Ventura County Community College District

DATE: June 12th, 2023
TO: All Bidders
FROM: David Cienfuegos, Purchasing Specialist
SUBJECT: Addendum 2 – Bid 650, Moorpark College Sand Volleyball Project

10 MAINTENANCE ACCESS CHAIN LINK FENCE GATE
NTS

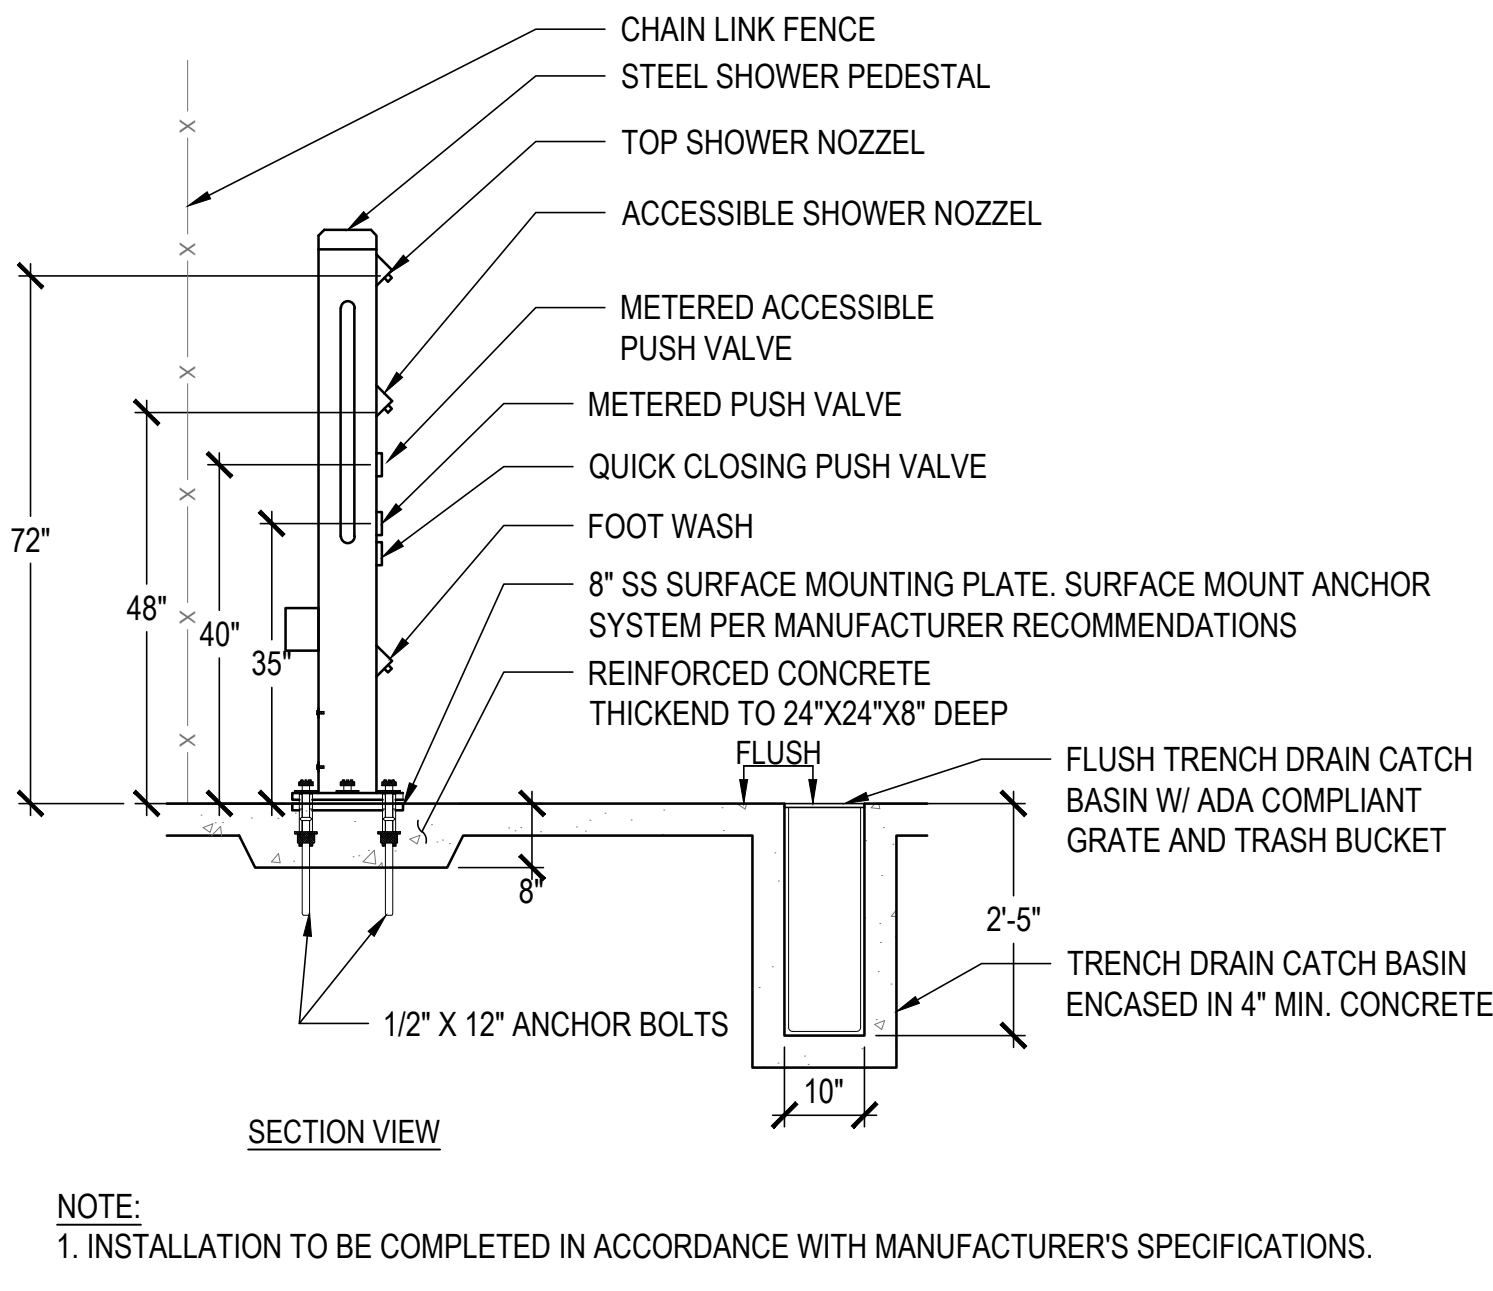
6. Please clarify the new work/scope on detail 10/C3-02 for the maintenance CL fence gate.

Response: Refer to revised detail 10 on sheet C3-02 Surfacing Details. Modifications to gate include added signage in detail as shown per DSA requirements.

REVISED ELECTRICAL SINGLE LINE DIAGRAM
SCALE: NONE SAND VOLLYBALL COURTS

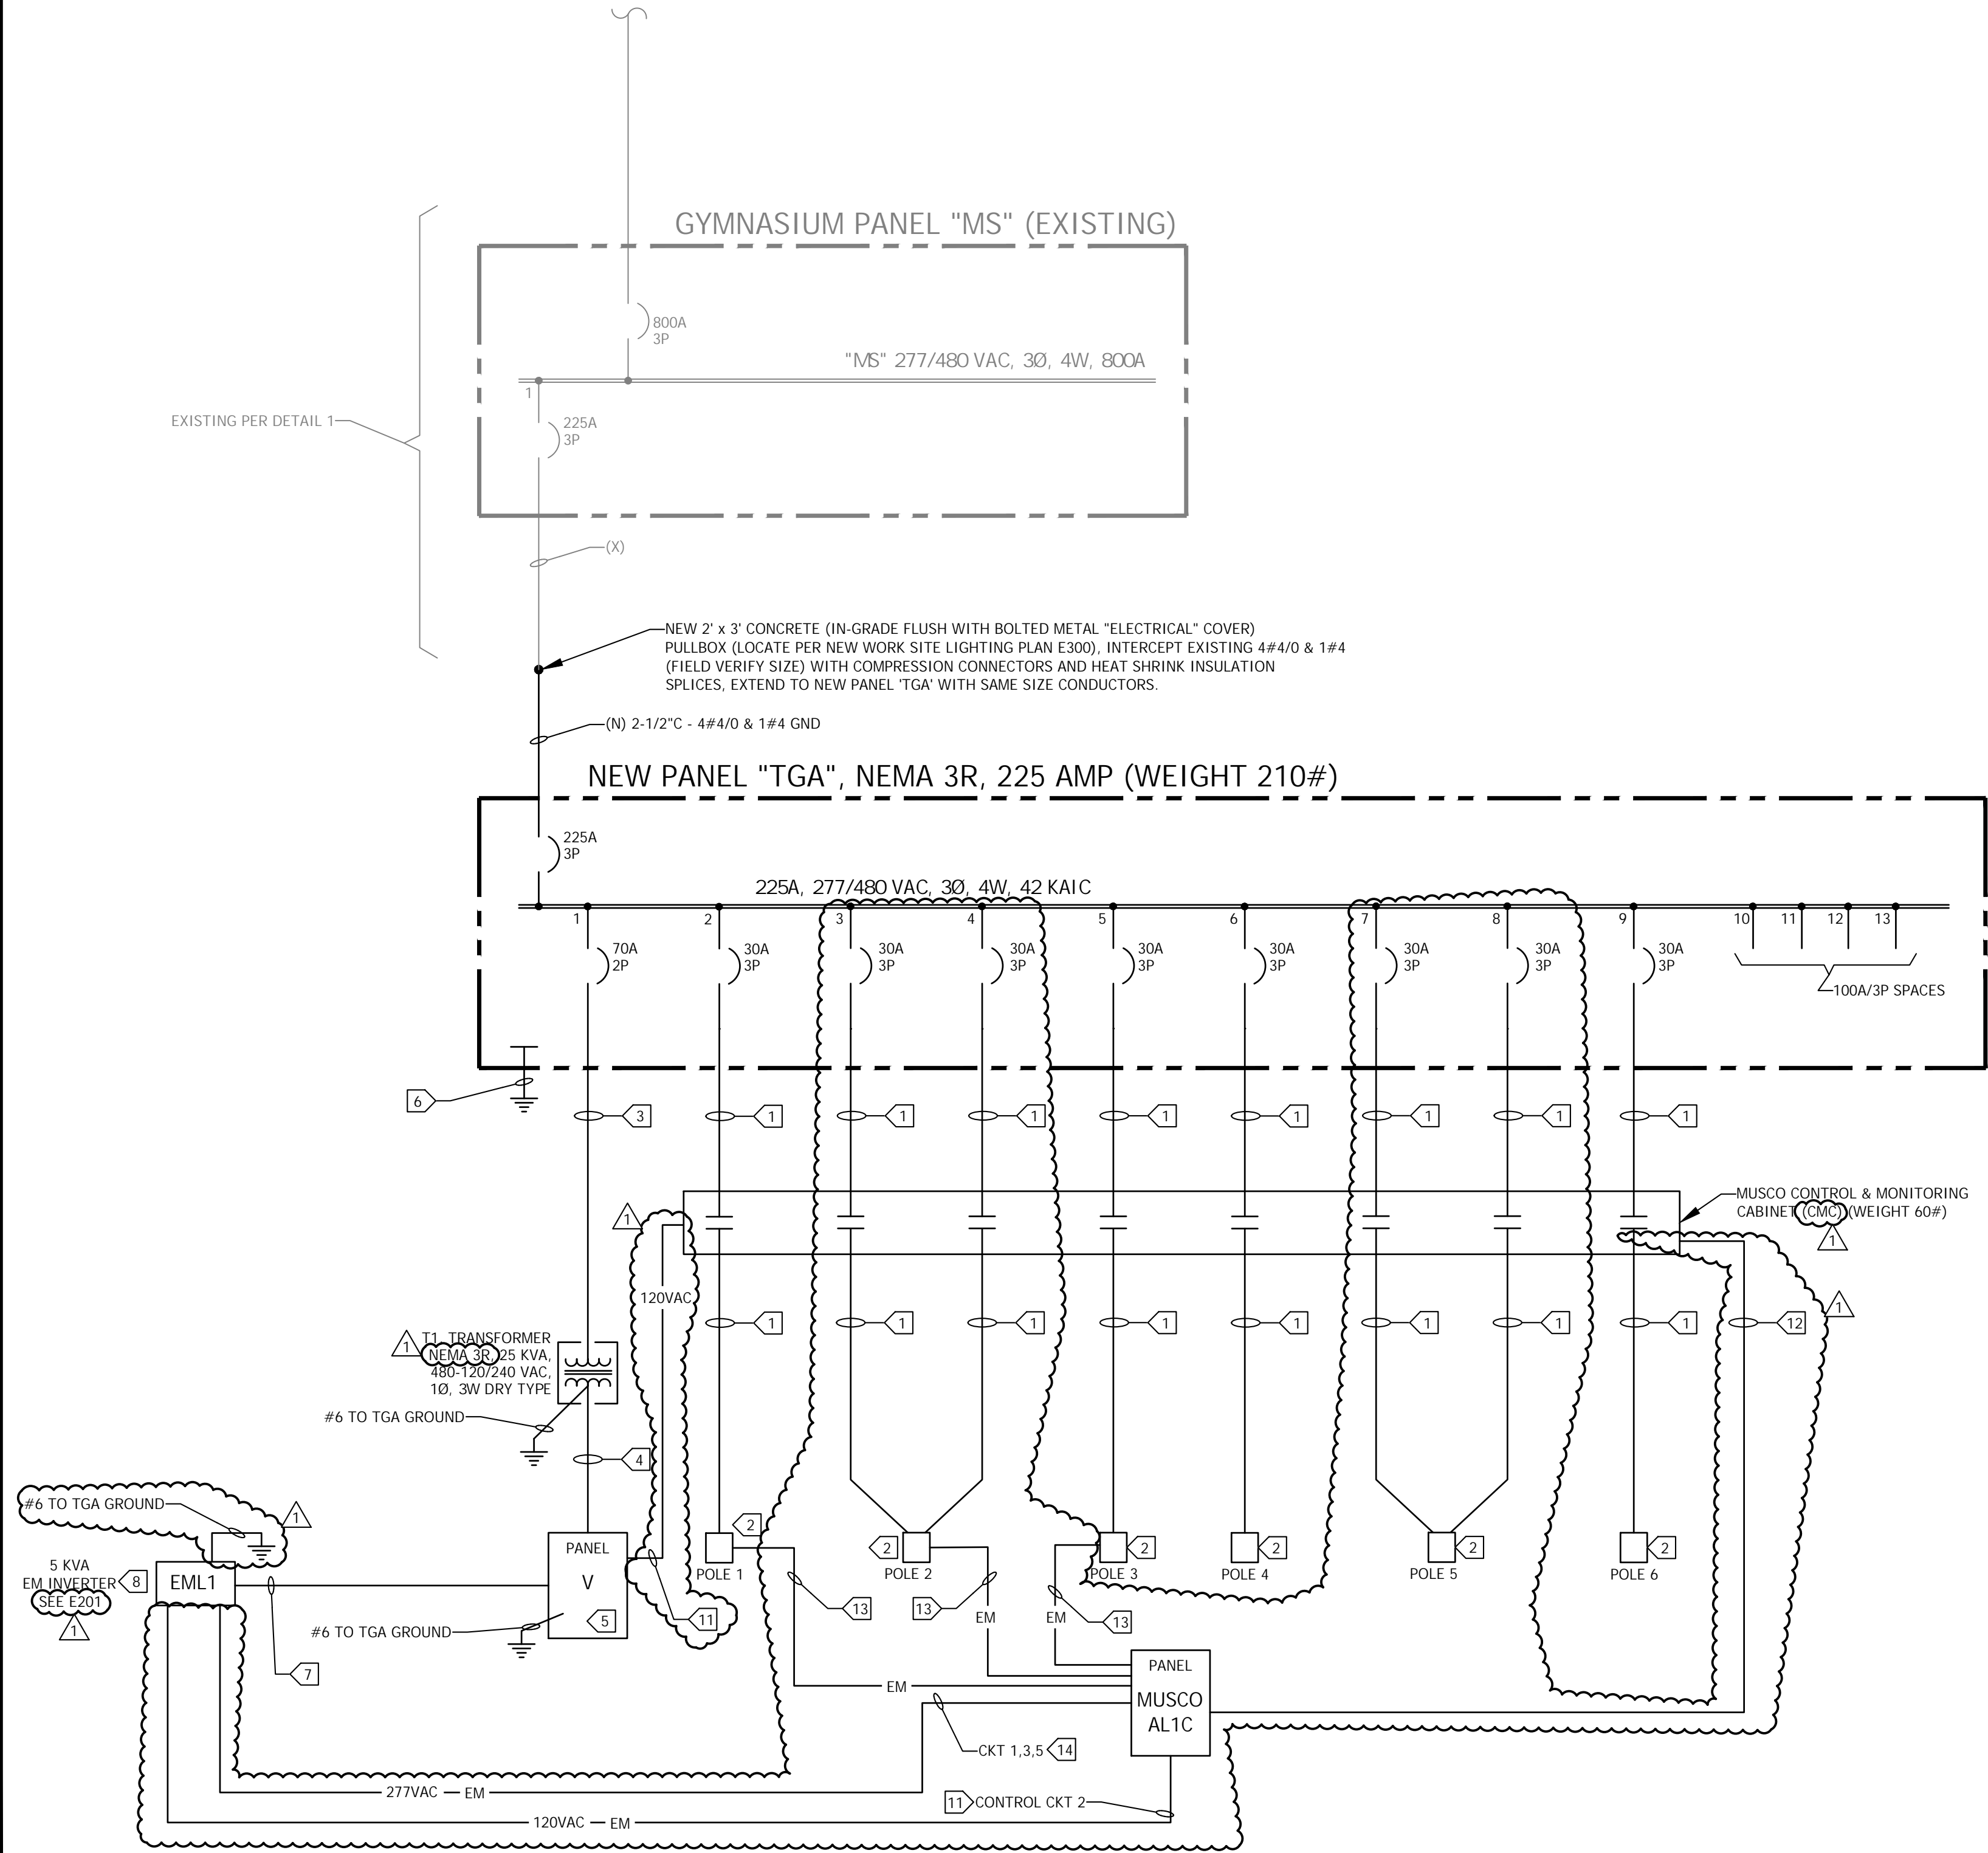
10. Please clarify the trench path for the electrical feeder to the gym. Also, advise the finish surface that must be repaired for trenches. Please provide details on how to enter the electrical room inside the gym.

Response: On E200 detail 2 key note above Panel TGA shows the new pull box at the intercept point as noted by keynote 4 on E300, no asphalt paving is to be removed. This intercept point is near to the new Panel TGA location. Trench finish shall be per details 3/E300 and 5/E600, all fill shall be concrete/sand slurry with tracer/warning tape above.
